**Permit Application Review Report**  
**Date: 11/5/2025**

**Project Name:** Trustone FCU Blaine

**Project PAN:** P-25-030

**Project Purpose:** Construction of a new commercial building, parking and associated stormwater treatment features

Figure 2: Site Plan

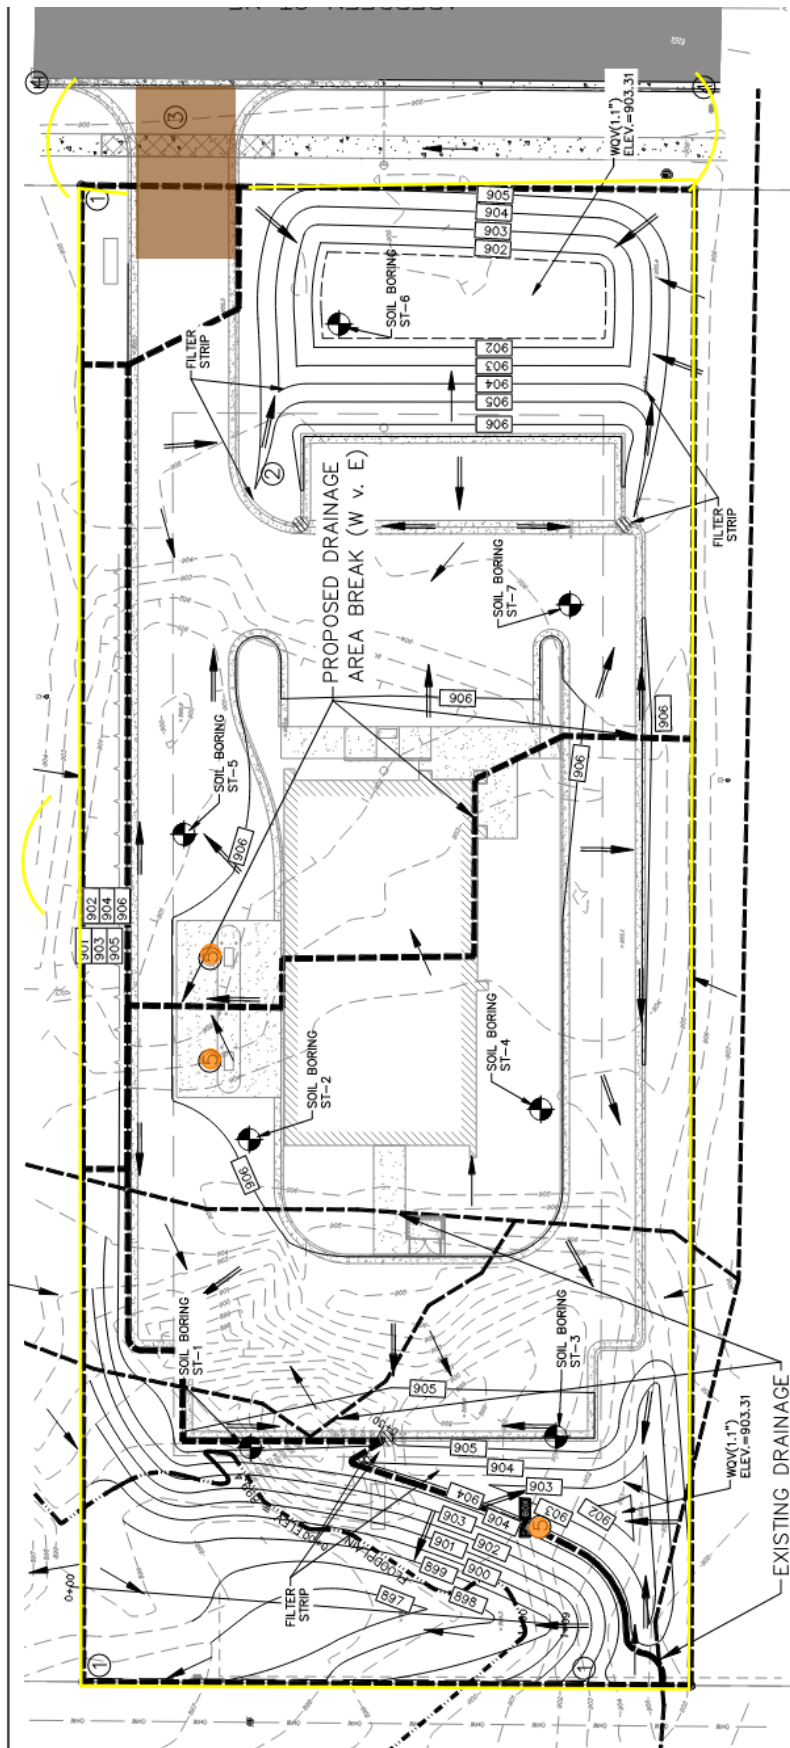
2. Provide proof of recording of a fully executed Operations and Maintenance Agreement for the perpetual inspection and maintenance of all proposed stormwater management practices after review and approval by the District.
3. Please update plans to include the following:
  - a. Please update the RCS-1 detail on sheet C-7 to show the 4" orifice within the weir wall.
  - b. Please update the RCS-1 label of sheet C-4 to state "3' wide weir at 903.10 w/ 4" orifice at 903.10".
  - c. Please update the infiltration basin labels on sheet C-3 to list an outlet elevation

of 903.1.

Figure 3: Soils and Erosion Control

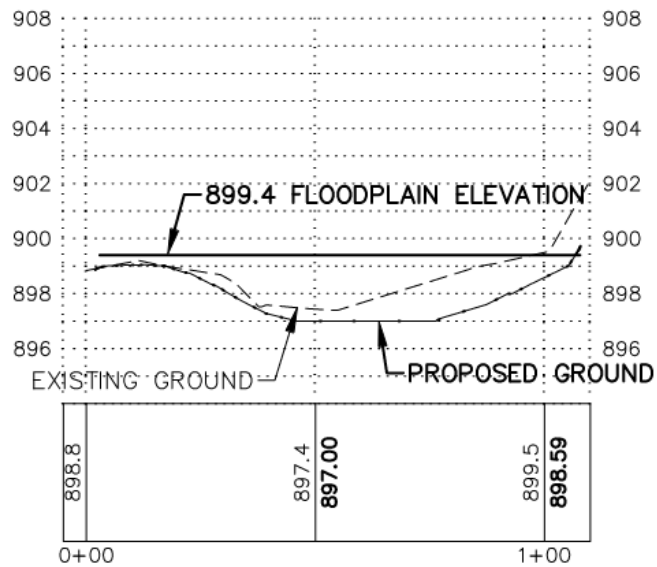
4. Update the erosion control plan to include the following:
  - a. Stabilize soils and soil stockpiles within 24 hours of inactivity.
  - b. Provide cover for stormwater contaminants.
  - c. Secure portable toilets.
  - d. After initial grading, completely surround the infiltration basins with perimeter control to prevent compaction during construction.

The proposed project drains to Ditch 60. The soils affected by the project includes Isanti, Rifle and Zimmerman and have a soil erodibility factor of 0.15 or greater. Disturbed areas are not proposed to be stabilized within 24 hours, as required. The proposed erosion and sediment control plan includes perimeter control, inlet protection, and a stabilized construction entrance. The erosion control plan does not meet District requirements because soils and soil stockpiles are not proposed to be stabilized within 24 hours of inactivity, waste is not proposed to be stored in seal containers, infiltration basins are not proposed to be surrounded by perimeter control, and portable toilets are not proposed to be secured. The site does not require an NPDES permit. See attached Figure 3: Soils and Erosion Control Plan.

Figure 4: Floodplain Impact

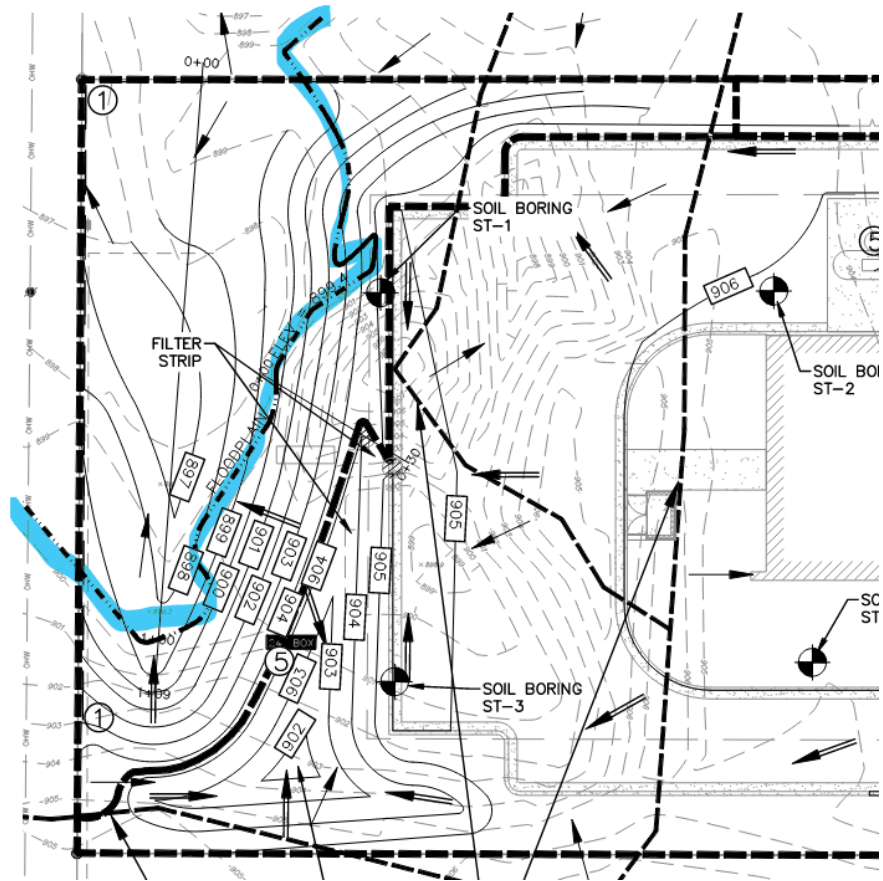
The regulatory floodplain elevation is 899.4 ft NAVD 88. The application proposes the placement of 134 cubic yards of fill within the floodplain. Compensatory storage is required. The proposed project provides 140 cubic yards of compensatory storage, which exceeds the required 1:1 ratio and is within the relevant reach.

The proposed fill within the floodplain is an embankment. Information has been provided to show that the embankment can pass the 100-year flood without increasing the elevation of the 100-year

flood profile or creating excessive velocities. Adequate compensatory storage is provided. See Figure 4: Floodplain Impact.
